## Product Change Notice (PCN)

**PCN Number: PCN-0450092R-01**

Product(s) Affected: PJ-003A, PJ-003B, PJ-003AH

Old version:

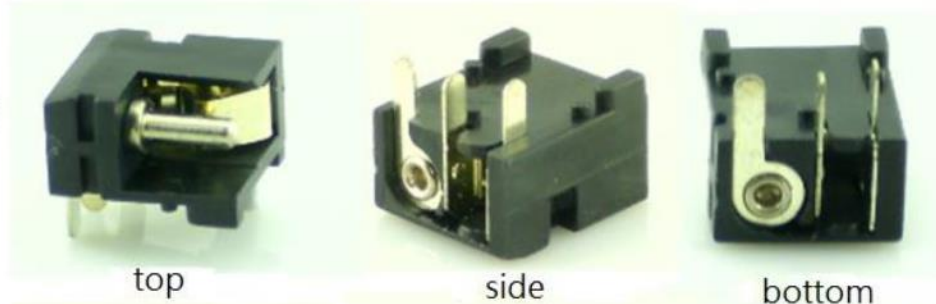
Description of Change: new mold design will adjust the appearance of the products. The electrical structure and function remain the same:
